**RE-PAINTING PLAN**  
 4 East Central Street (Lot 279-017)  
 FOR  
 James A. Colace/Abbruzzi Realty Trust  
 55 Court Street  
 Franklin, MA 02038

**Re: Proposed Parking Lot  
19 Cottage Street  
Site Plan and Special Permit Peer Review**

BETA Group, Inc. (BETA) has reviewed revised documents for the project entitled “**Proposed Parking Lot at 19 Cottage Street**” located at 19 Cottage Street in the City of Franklin, MA. This letter is provided to outline BETA’s findings, comments, and recommendations.

**RE: Site Plan & Special Permit – #19 Cottage Street**

**PROPOSED**  
Scale: 1 in = 20 feet

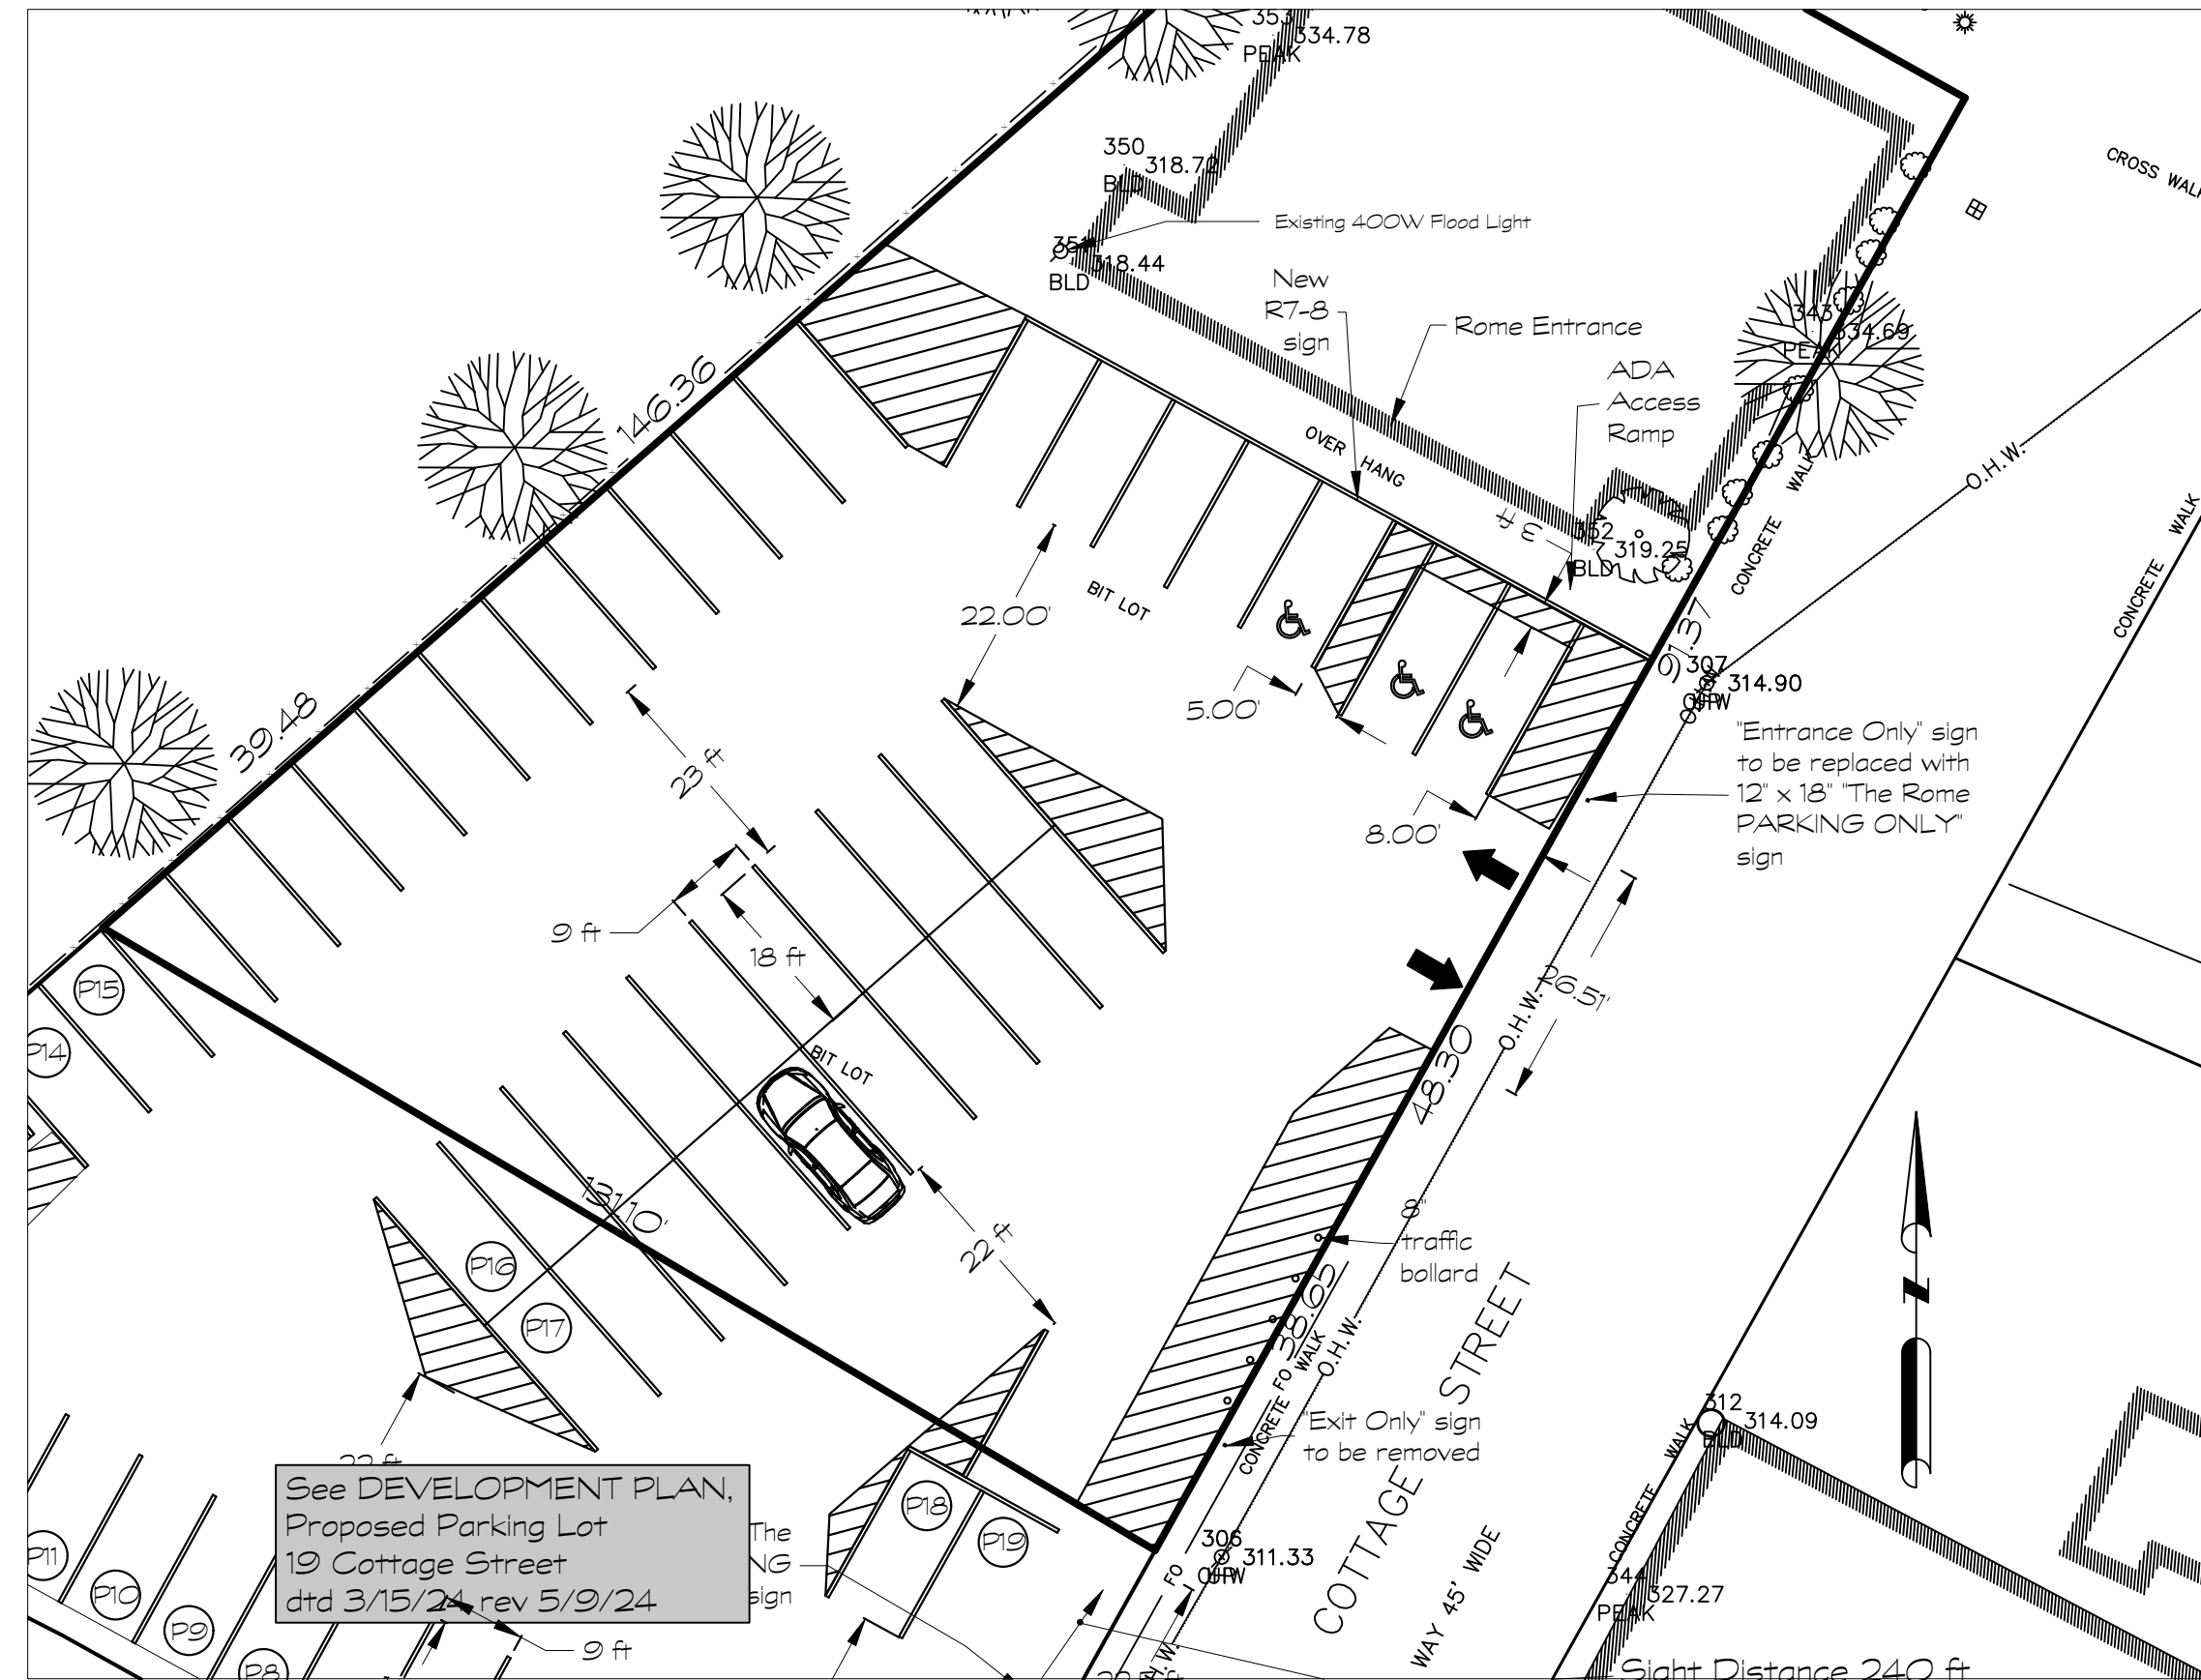
- G1. *Recommend expanding plan viewport to include the existing restaurant and identifying its main building entrance.*

- T5. *Work proposed along the site frontage, including the relocated driveway entrance (consistent with detail), sidewalks, and curbing should be clearly shown in the plan view.*

- T7. *Depict the existing driveway entrance on the plans for comparison to proposed entrance location.*

T10. *Confirm the total number of spaces in both lots and provide one additional accessible parking space, as required. Include an Accessible route per 521 CMR 20 from the proposed accessible parking space to the building entrance.*

T11. *BETA recommends that the applicant revise the existing accessible spaces to comply with 521 CMR 23.4.*

- SL2. *Provide required sign for accessible parking space (See parking and loading section).*

DUNBAR: The entrance and ADA access to The Rome restaurant has been added to Existing and Proposed plan views.

DUNBAR: As noted in the Response to Comment T2, the Town Engineer indicated the curb cut detail provided was adequate. I have added limits and labels to the PROPOSED plan to show the limits of the existing curb cut and the proposed extension.

DUNBAR: I have added limits and labels to the PROPOSED plan to show the limits of the existing curb cut and the proposed extension.

DUNBAR: See response to Comment Z1. The revised plan provides 19 new parking spaces on Lot 17 and re-painting on Lot 217 to provide 35 spaces, three of which are accessible spaces and one which is van accessible. The revised plan provides a total of 54 spaces and a net increase of 19 spaces. The Parking Legend on the DEVELOPMENT PLAN Sheet 24-01 has been updated to reflect this information.

***BETA2: Plan revised. For a total of 54 parking spaces, 3 accessible spaces are required. These accessible spaces will be provided in the northeast corner of the re-painted lot, and one of the spaces has been designed as van accessible. Issue resolved.***

DUNBAR: The revised plan provides three accessible parking spaces adjacent to the existing access ramp with one space van accessible space. Signage has also been added.

DUNBAR: Accessible signage exists for the two existing spaces (including “van accessible”). A third sign will be added as labeled on the PROPOSED plan. The R7-8 sign detail was added to the DETAILS Sheet 24-03.
